Buzzards Bay

*National Estuary
Program*

December 21, 2005

The Falmouth Department of Public Works has unveiled a preliminary plan to extend the Shining Sea Bikeway 6.2 miles along the old rail line in West and North Falmouth. I wish to call your attention to the fact that the original construction of the rail line, together with repair work after Hurricane Bob in 1991 (several areas of track bed were washed out), and the gradual collapse or filling of culverts with gravel, have restricted tidal exchange and flushing in at least five salt marsh sites along the planned bike path. These tidal restrictions, located principally in the area of great Sippewisset Marsh, have choked off and killed areas of salt marsh and degraded wildlife habitat by allowing the marshes to be overtaken by the common reed, Phragmites, and other nuisance species. Attached are maps (figures 1-2), aerial photographs (figures 3-6), and a table of information about these restrictions contained in our 2002 Atlas of Tidally Restricted Salt Marshes in the Buzzards Bay Watershed. (data in Table 1 from CD version database).

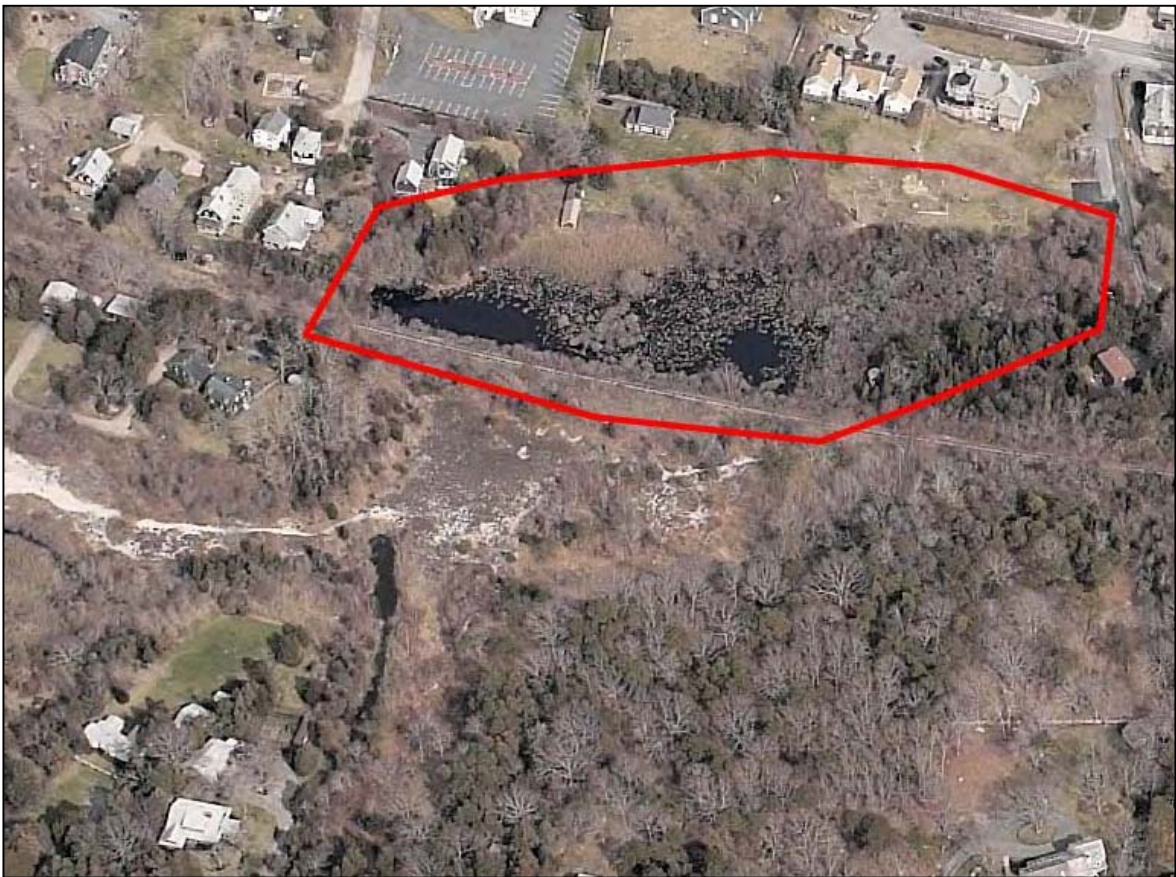
It is also worth stressing that some tidal restrictions caused by the bike path should not be restored. The long flooded area west of the tracks in the vicinity of Nonamesset Road near Snug Harbor in West Falmouth should be left as is. The lack of drainage from either poor designs or lack of maintenance long ago created a small freshwater wetland and pond at that site, and these wetlands should be preserved.
